From: Ellen Hardgrove, AICP, City Planning Consultant

Date: May 18, 2015

Re: Special Exception for Brazilian Church @ 1110 Holden Avenue as identified in red below

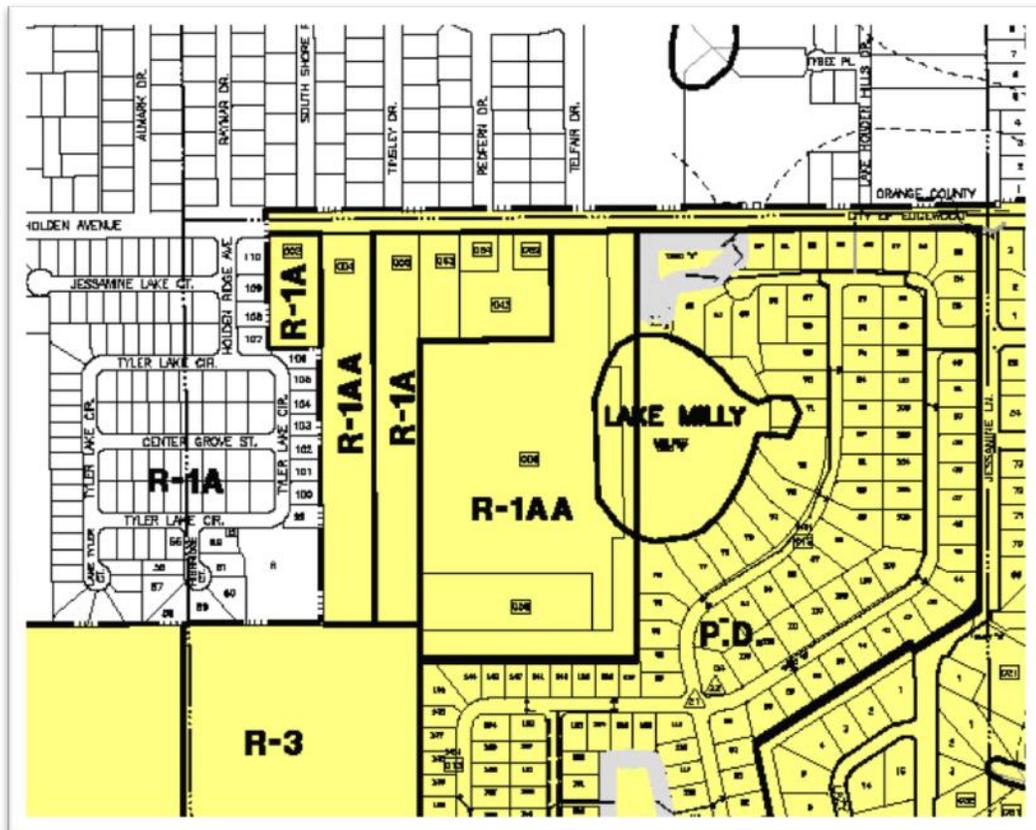
A site plan for the proposed church has been submitted with the application and is to be considered by the Planning and Zoning Board and the City Council. There are two main concerns with the site plan. First, a significant portion of the property will remain undeveloped; second, the blending of the use into the surrounding residential area; and third, the site plan is missing development requirements of the City's Code.

The site plan shows an 8400 square foot building, including a 239 seat sanctuary, fellowship hall/kitchen, and meeting rooms, with a delineated area for "future gymnasium/sports field" and a pond for stormwater management. About 1/3 of the site will remain undeveloped. Although another public hearing would be required for any proposed expansion of the church,

The Holden Avenue corridor is residential in character. The relatively narrow lot width and road frontage (187 feet) combined with the requirement of an 8 feet high wall along the sides of the vehicular use area (see below) will result in a tunnel appearance. The other churches along Holden have a greater road frontage:

Another issue of blending is the proposed building type of the proposed church. The proposed look of the church is more industrial, than residential.

Parking – A conforming number of spaces cannot be determined. Code requires 1 parking space per 3 seats, plus one space per employee. The site plan shows a sanctuary with 239 seats. The number of employees has not been identified. Furthermore, the layout of the parking spaces is missing the required landscaping breaks.

Per Section 114-4.1.c.4, for the rows along the property lines, a maximum of ten continuous parking spaces is permitted without a landscape break. The landscape break must be a minimum of eight feet in length and eight feet in width. Pertaining to all rows of parking, including the handicapped accessible spaces, per Section 114-4.1.c.5, a landscaped island (singular or head-to-head) is required at the ends of each row of parking spaces.

Wall –Section 134-608(c) requires an eight feet high maintenance-free concrete, masonry, or other permanent material wall when driveways and parking lots are adjacent to residential zoned property.

Solid waste storage areas - A solid waste storage area is not shown. A location needs to be identified. Further, the solid waste refuse facility must be screened on three sides by a six-foot high masonry wall if it is located within the building setback area or located in an area visible to customers or from a public right-of-way.

Building Perimeter Landscaping - As a note, the building placement needs to be shifted to the east to accommodate the required building perimeter landscaping along the primary façade (west). The landscaped area must be equal to the full linear length of the building base and have a minimum depth of eight feet. The layout of the required landscape is at the discretion of the owner; however, each perimeter requiring landscape must have at least 50 percent of the required landscape along that perimeter.

In addition to missing requirements, adjustments to the site plan are recommended to minimize the impact to the adjacent road. The site plan shows two curb cuts, with one an ingress, the other an egress. One combined ingress/egress curb cut is recommended to minimize points of vehicular conflict and preserve the capacity of the road. Furthermore, the curb cut into the property should be aligned with Tinsley Drive for the same reason.

Although Section 134-141(a) specifies the requirement only applies to development within any commercial or office zoning districts, pedestrian walkways and linkages should be provided to the adjacent street and sidewalks. Pedestrian ways are also required to provide access between parking areas and the building entrance. Pedestrian walkways are to be a minimum of five feet wide. Materials may include concrete, brick, or others as approved by the city.

Similarly, per Section 134-142., vehicular and pedestrian cross access shall be provided between adjacent parcels.

Unless the applicant can resolve the above issues of blending with the adjacent neighborhood in appearance and traffic control and incorporate the site plan changes recommended by the City Planner and City Engineer, staff is recommending denial based on the finding that the proposed use is incompatible with the neighborhood character, and will have negative impacts on the value of surrounding lands, and will adversely affect the public interest.
